SUBDIVISION REVIEW SHEET**CASE NO.:** C8-2016-0018.0A**P.C. DATE:** February 28, 2017**SUBDIVISION NAME:** Resubdivision of Lots 15 and 16, Post Road Addition**AREA:** 0.808 acres**LOT(S):** 3**OWNER/APPLICANT:** Bodhi Group, LLC
(Yusof Johnson)**AGENT:** Land Answers, Inc.
(Jim Wittliff)**ADDRESS OF SUBDIVISION:** 232 Lessin Lane**GRIDS:** M23**COUNTY:** Travis**WATERSHED:** East Bouldin**JURISDICTION:** Full**EXISTING ZONING:** SF-3-NP**NEIGHBORHOOD PLAN:** Dawson**PROPOSED LAND USE:** Single-Family

MEMORANDUM

SUBJECT: C8-2016-0018.0A Resubdivision of Lots 15 and 16, Post Road Addition

FINAL PLAT OF
RESUBDIVISION OF LOTS 15 AND 16, POST ROAD ADDITION

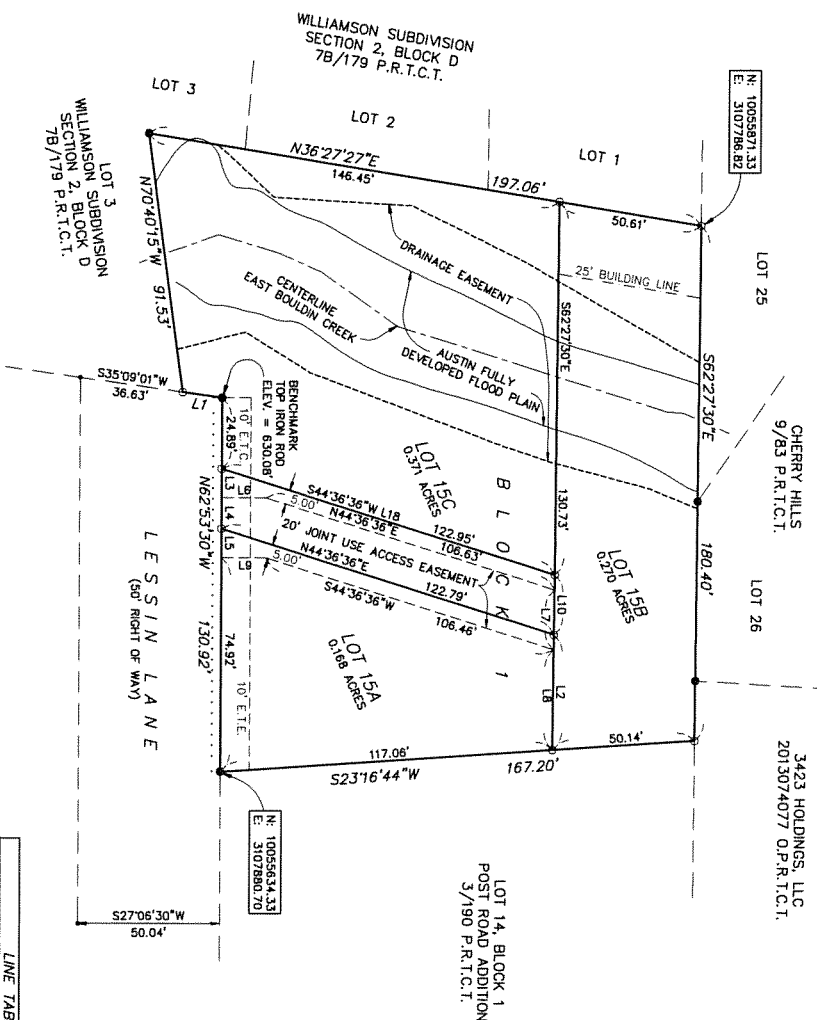
The applicant for the above referenced subdivision application has requested a variance from Section 25-4-175(A)(2) of the Land Development Code to utilize a flag lot design for a resubdivision creating three residential lots with one flag lot. In reviewing the variance request, staff evaluated the request based upon the criteria below, (see criteria and staff response):

The applicant has met with Austin Fire Department review staff and AFD staff has determined that the flag lot configuration proposed will not inhibit accessibility for emergency responders.

The applicant has provided a driveway and utility plan to reviewers for the City of Austin Water and Wastewater review and Austin Energy Departments. The reviewers have determined after review of the utility/driveway plan that there is adequate room to provide utility service to both lots and utilities will not cross the proposed new lot lines.

The applicant has provided a tree survey to arborist staff with the City of Austin and the arborist have no objections or further recommendations.

The plat proposes a flag lot that has a size comparable to existing lots on Lessin Lane. The flag lot would also be compatible with the two-unit residential or secondary apartment uses on the subdivision block.

Based upon review of these criteria, staff **recommends** the variance request to develop a flag lot as a part of this resubdivision request.
